Access Compliance Report Public Rights-of-Way (Curb Ramps)

Main Street: THIRD_RD Cross Street: N/A Location: SW

ADA ID: RPRK220223143035 Ramp Type: Type 4 - Parallel Initial Pass/Fail: Fail Overall Compliance: No Severity Score: 15

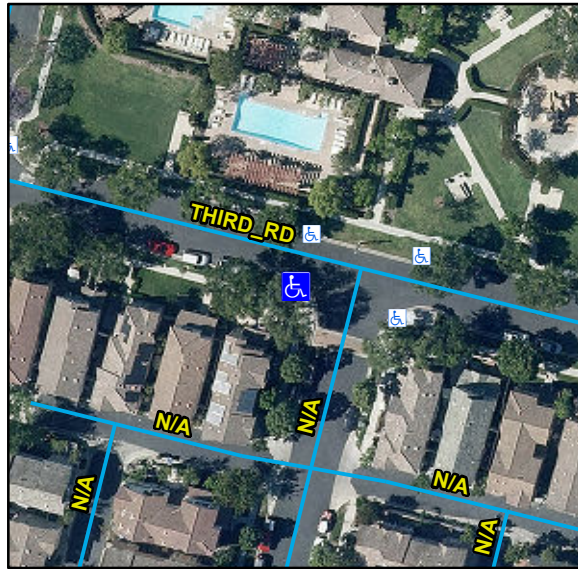
Compliance	Description	Data	Compliance	Description	Data
N/A	Ramp Length LT (in)	110	N/A	Ramp Length RT (in)	114
Yes	Ramp Width LT (in)	90	Yes	Ramp Width RT (in)	90
Yes	Ramp Run Slope LT (%)	0.5	Yes	Ramp Run Slope RT (%)	3.2
No	Ramp Cross Slope LT (%)	5.1	No	Ramp Cross Slope RT (%)	6
N/A	Landing Present	N/A	N/A	DWS Provided	N/A
N/A	Landing Length (in)	N/A	N/A	DWS Contrast	N/A
N/A	Landing Width (in)	N/A	N/A	DWS Length (in)	N/A
N/A	Landing Run Slope (%)	N/A	N/A	DWS Full Width	N/A
N/A	Landing Cross Slope (%)	N/A		DWS Offset Type	N/A
N/A	Landing Movement Obstructed?	N/A	N/A	DWS Offset Left (in)	N/A
	Landing Movement Type	N/A	N/A	DWS Offset Right (in)	N/A
N/A	Landing Shared	N/A			
N/A	Clear Space	Yes			
N/A	Clear Space To Crosswalk (in)	48			
N/A	Marked Crosswalk 1	No	N/A	Marked Crosswalk 2	No
	Crossing 1 Direction	E		Crossing 2 Direction	N
N/A	Marked Crosswalk 1 Width (in)	N/A		Marked Crosswalk 2 Width (in)	N/A

Remove & Replace Curb Ramp With Two New Directional Ramps or Equivalent.
